Information Letter 25001

SUBJECT: Lynx D Battery New & Old Power Terminal Compatible Solution Notice

AFFECTED: Lynx D (The first three digits are 50G, and the tenth digit is D)

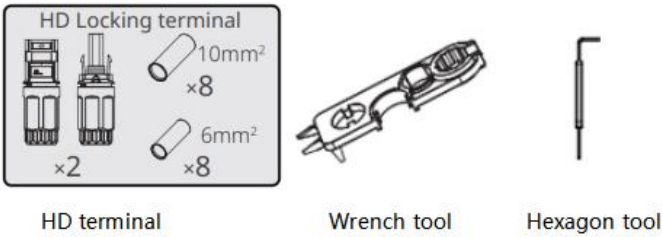
Scenario 1 The customer's **base accessory package SIB0724-00-00P or Wall mounting rack package SIB0725-00-00P (with the old battery terminal)** needs to be matched with a new HD

terminal battery. The new HD terminal accessory package(**SIB1189-00-00P**) needs to be obtained in advance.
